North Hertfordshire District Council

Building Conservation comments

File Ref: 24/02060/FPH & 24/02061/LBC

Address: Julians, Julians Park, Rushden, Buntingford, Hertfordshire, SG9 0TD

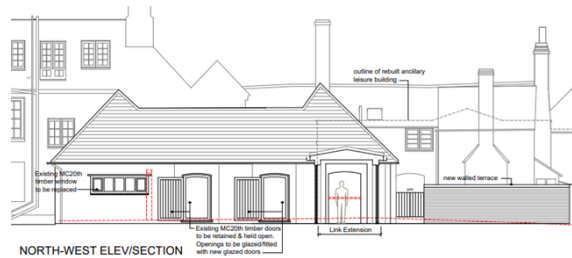
2.10 To address SPAB's objection to the proposed interventions within the Butler's Pantry Corridor, consideration could be given to retaining existing doors, cupboards and panelling. I appreciate that I previously stated a "consequence of removing the C20 partitions forming the Butler's Pantry/Laundry, the amended layout provides the opportunity to reinstate the C17 fireplace and bressummer beam to the proposed kitchen and dining area". However, I can be convinced of an alternative approach offered by SPAB which is to do less, and I am not entirely convinced that to reinstate an overmantle in what would be an opened-up space adjacent to the external doorway leading to the Butler's Pantry Corridor is fully justified. Not interfering with this space would enable two existing doors to also be retained in-situ (see 2.7).

5. The existing internal doors to the Butler's Pantry (D1) and the kitchen door adjacent shall be repaired and retained in-situ unless otherwise agreed and approved in writing by the Local Planning Authority.

4.0 **Proposed Elevations – drawing no. 2309/PD/204 Rev H**

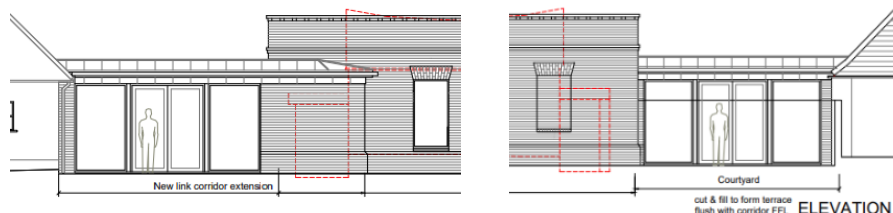
The introduction of fully glazed doors to the south elevation is problematic. The harsh visual properties of an unbroken expanse of glass can be a stark contrast with the surrounding historic brickwork. We therefore encourage the applicant to consider a design that incorporates smaller glass panels within a timber frame if there is a need to introduce more light to the internal space. We are also not convinced that the rehanging of the historic doors onto parliament hinges would work well in practice, further detailed drawings should be provided to show the impact that the proposals will have on the historic fabric.

- 4.2 I note the point made here and if the doors are set on parliament hinges, I assume it would be the inner face of the doors which would appear externally against the building. I am less perturbed by the fully glazed doors which, whilst contrasting, would not in my view be harmful. It is noted that due to the projecting brickwork surrounds, only part of each door would sit completely flush against the brickwork. Alternatively, I am prepared to consider, for instance, stable doors in these openings which could be fully or part-opened in good weather.

3. All new windows and external doors shall be manufactured in timber and the windows shall be externally white-painted unless otherwise agreed and approved in writing by the Local Planning Authority.
